Natural Gas Pipeline Relocation

Petition for Post-Certification Change

For the Otay Mesa Energy Center Otay Mesa, California 99-AFC-05C October 2021

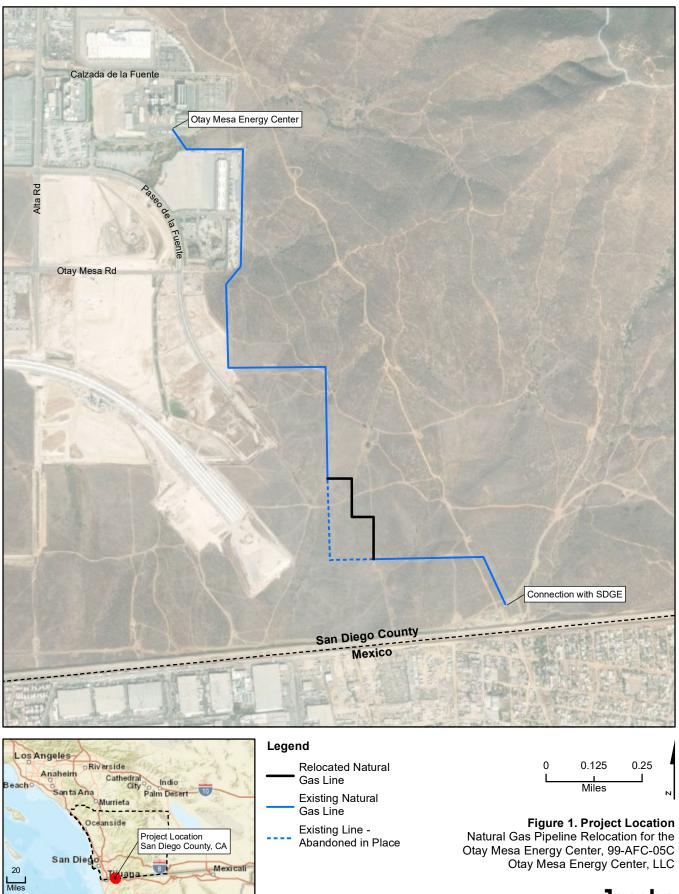
The project change will include the installation of approximately 1,700 feet of 24" gas pipeline within a 50-foot wide easement provided by Caltrans, designed and built to the same standards and specifications as the existing line. It will be laid in a trench 2 to 3 feet wide with approximately 4 to 5 feet of cover. The bypassed section will be abandoned in place. No new valves or other equipment will be installed.
